| Flight Procedures Cover Page | Task Action: FLIGHT CHECK | Task Type: IAP | Estimated Chart Date: 08/12/2021 | APWS Task ID: 94E9C50BA70545E5BD73176D21DE2CC9 | APWS Project ID: C48AA67E39E64E2AA18B65B50ADBE769 |
| Procedure: RNAV (GPS) Y RWY 32 AMDT 3 | | Enroute: NO | Specialist: Johnson, Raymond | | Agreement Number: |
| Airport ID: KPBI | | | Airport City: WEST PALM BEACH | | State: FL |

RNAV (GPS) Y RWY 32

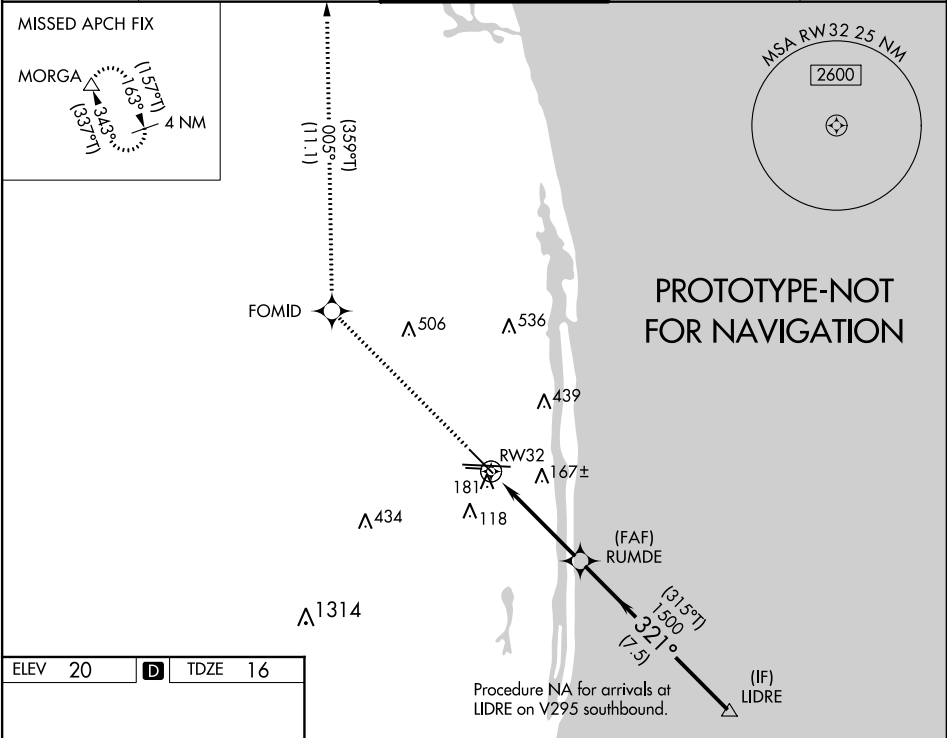
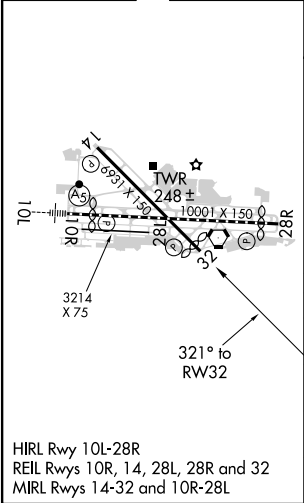
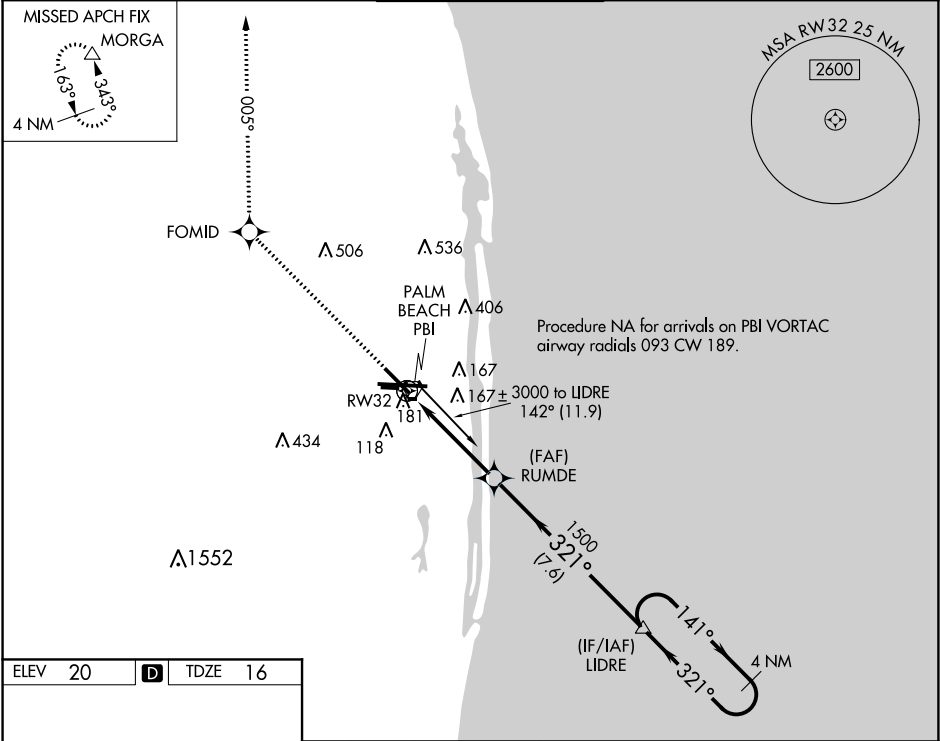
| <p>Procedure Comments: PROCEDURE COMPLETED USING PENDING DATA.</p> <p>LOA FOR 3.00 DEGREE VDA.</p> <p>CRC REMAINDER CHANGED FROM 30C70719 TO 07F09924.</p> <p>CONTACT JASON KRETSCHMER, AJV-A421, (405) 954-4019.</p> <div style="text-align: center; margin-top: 200px;"> <i>Digitally signed by</i> JASON KRETSCHMER May 14, 2021 </div> <div style="text-align: right; margin-top: 100px;">   </div> | | | | | |

| RNP APCH - GPS. | | | MISSED APPROACH: Climb to 3000 direct FOMID and on track 005° to MORGA and hold. | |
| ⚠ Circling to Rwy 10L NA at night. Rwy 32 helicopter visibility reduction below ¾ SM NA. ⚠ For uncompensated Baro-VNAV systems, LNAV/VNAV NA below 6°C or above 54°C. | | | | |

| <div><div>⚠</div><div>For uncompensated Baro-VNAV systems, LNAV/VNAV NA below -15°C (5°F) or above 48°C (118°F). DME/DME RNP-0.3 NA. Helicopter visibility reduction below ¾ SM NA.</div></div> | MISSED APPROACH: Climb to 2000 direct FOMID and via track 005° to MORG A and hold. |

FAAO 8260.3D, para 2-6-2b. Glidepath Angle (GPA) and Vertical Descent Angle (VDA). Flight Standards approval is required to establish a VDA that is less than the angle of a VGSI installed to the same runway.

Runway 32 VGSI at PALM BEACH INTL (WEST PALM BEACH, FL) (KPBI), has a commissioned angle of 3.25 degrees. RNAV (GPS) RWY 32 was flight inspected SAT at 3.00 degrees and TCH of 57. The 20:1 visual surface is clear. Request approval to publish a 3.00 VDA.
